CT7-2E1 SERVICE BULLETIN - 72-0030 R00

SB 72-0030 R00 ENGINE - COLD SECTION MODULE (72-30-00) - RELEASE OF
REDESIGNED COMPRESSOR CASE P/N 5168T76G05

Compressor Case
Figure 1

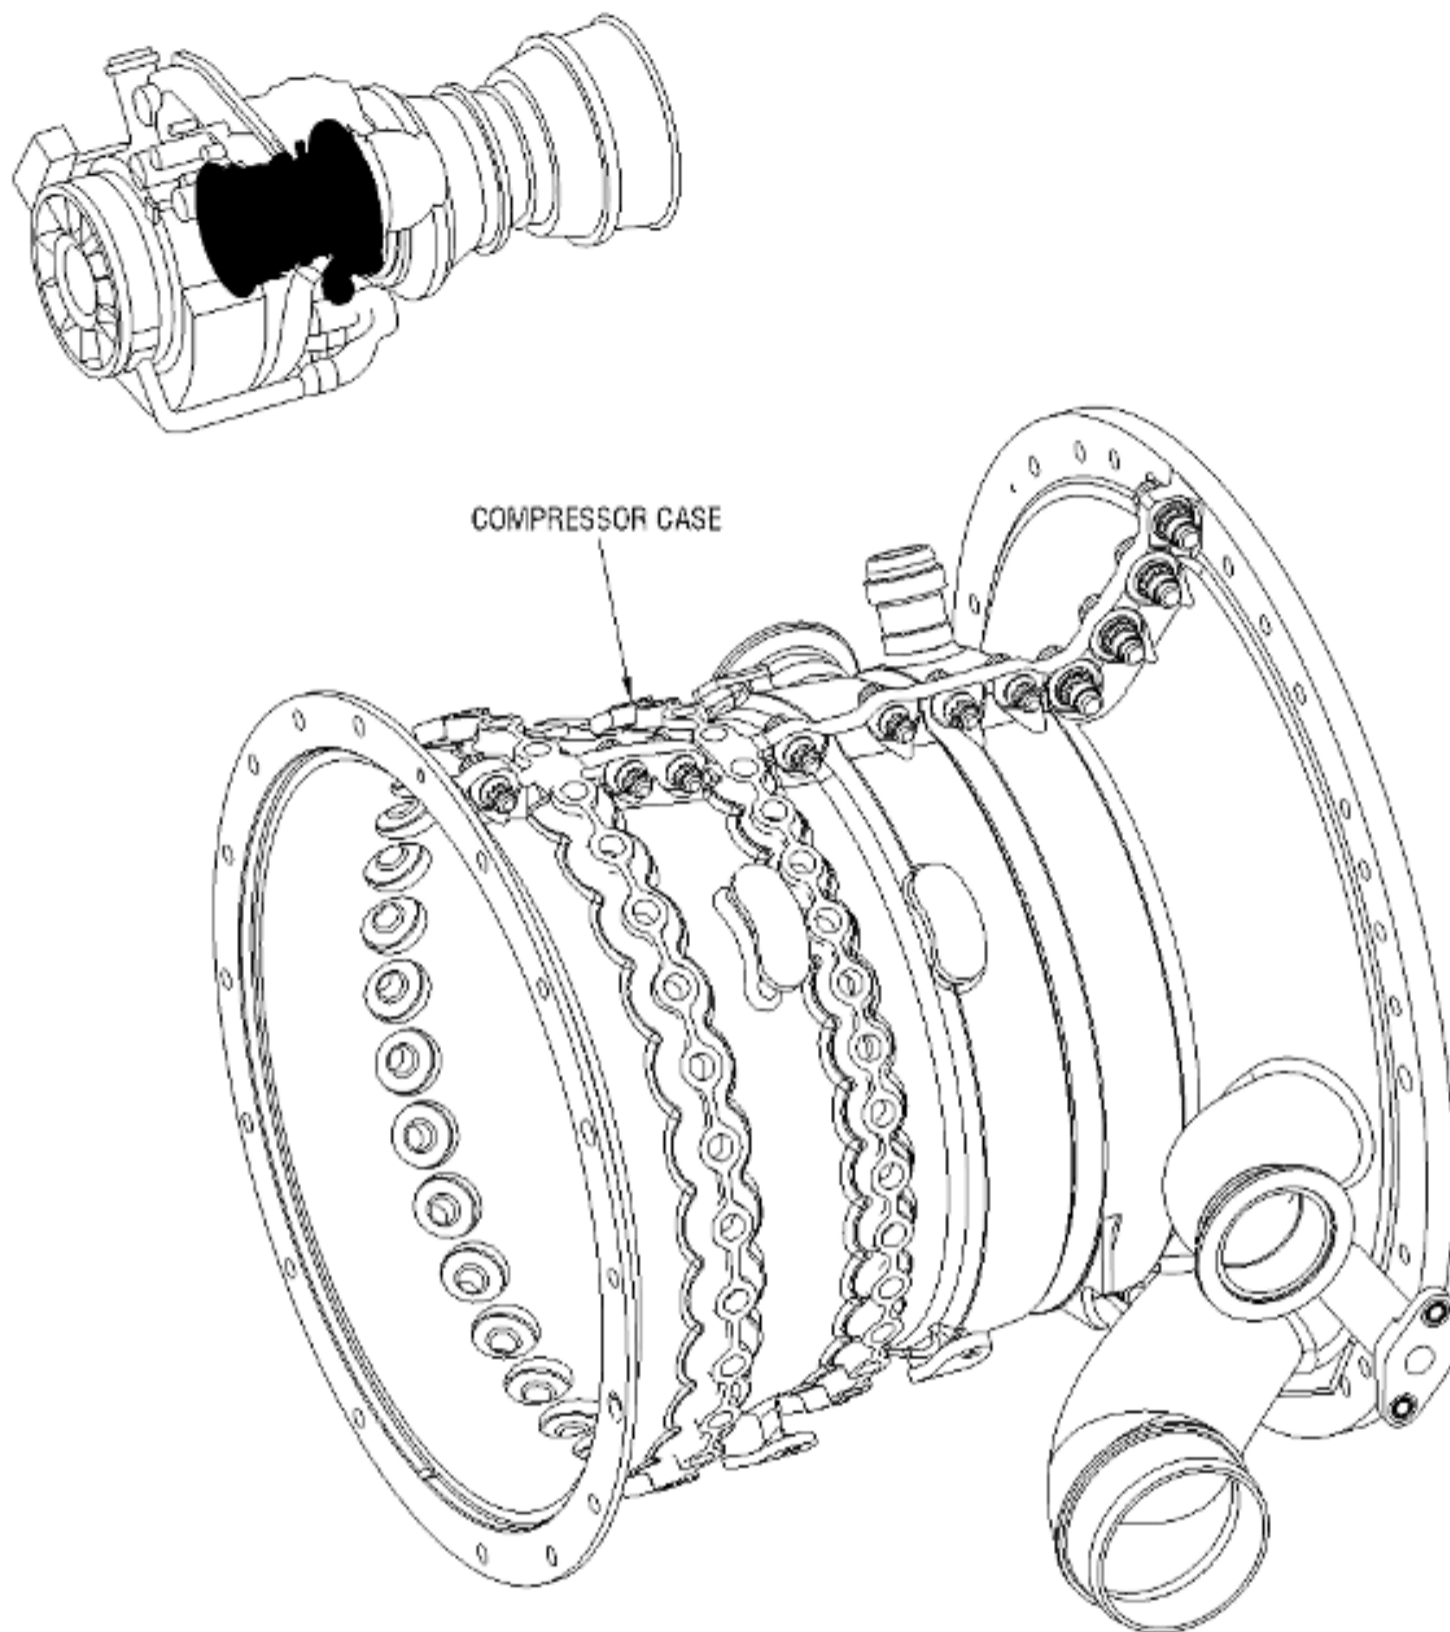
This Service Bulletin introduces compressor stator assembly P/N 6039T60G28 with a redesigned compressor case.

To replace the current compressor stator assembly P/N 6039T60G27 with a new compressor stator assembly P/N 6039T60G28 which uses redesigned compressor case P/N 5168T76G05 with improved life.

Due to the geometry of the current compressor case split-line flange counterbores, component life is low.

Compressor case P/N 5168T76G04 was certified with a life below the program requirement.

Updated cold section module with a new compressor stator assembly P/N 6039T60G28 assures that compressor case life will be improved.
